Work Order ID 141153

Item Name: Replacement Skidtube (Fits LH or RH)

DRAWING NO. D2650	TITLE 206/407 SKIDTUBE ASSEMBLIES	REV. F	DART AEROSPACE LTD ENGINEERING ORDER		D.E.O. NO. D2650-F-1	SHEET NO. SHEET 1 OF 1	SCALE NTS
DRAWN <i>[Signature]</i>	CHECKED A.P.	MFG. APPR. <i>[Signature]</i>	APPROVED <i>[Signature]</i>		DE APPR. <i>[Signature]</i>		
DATE 12.10.12	DATE 12.10.22	DATE 12.10.22	DATE 12.10.22		DATE 12.10.22

CHANGE C'BORED WELDED CROSSBOLT SPACERS TO SWAGED SPACERS

AMENDMENT TO DETAIL B
NOT TO SCALE

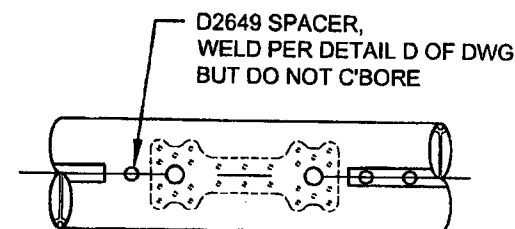
ADD DETAIL G BELOW, WHICH IS THE SAME SECTION VIEW AS DETAIL D OF DWG.
C'BORED HOLES ARE **NOW SWAGED** PER DETAIL G BELOW. FOR THE Ø0.375 HOLE THAT IS NOT C'BORED, WELD PER DETAIL D OF DWG (SEE AMENDED DETAIL B FOR REFERENCE).

DETAIL G

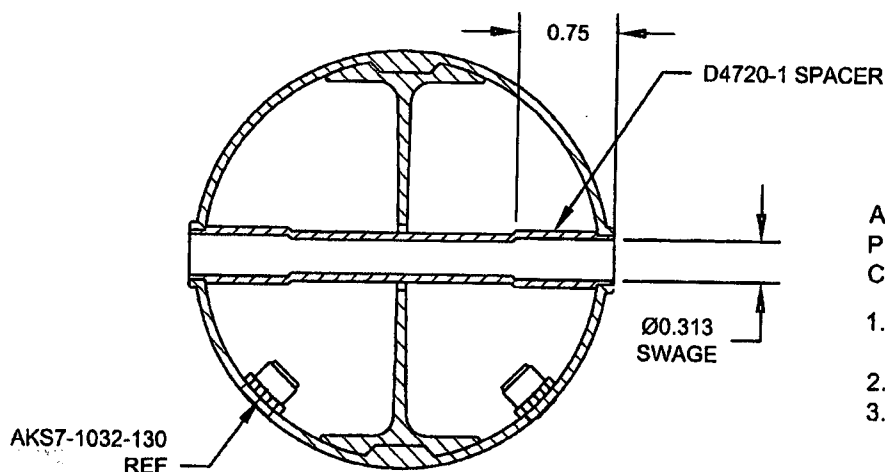
AFTER DRILLING AND BENDING ASSEMBLY
PERFORM THE FOLLOWING FOR Ø0.375 HOLES THAT ARE
CURRENTLY C'BORED:

1. INSERT D4720-1 SPACER, 16 PL (-1) OR 17 PL (-3)
OR 19 PL (-5) OR 23 PL (-7)
2. SWAGE TO Ø0.313 X 0.75 DP PER QSI 002
3. TRIM / GRIND FLUSH PER QSI 002
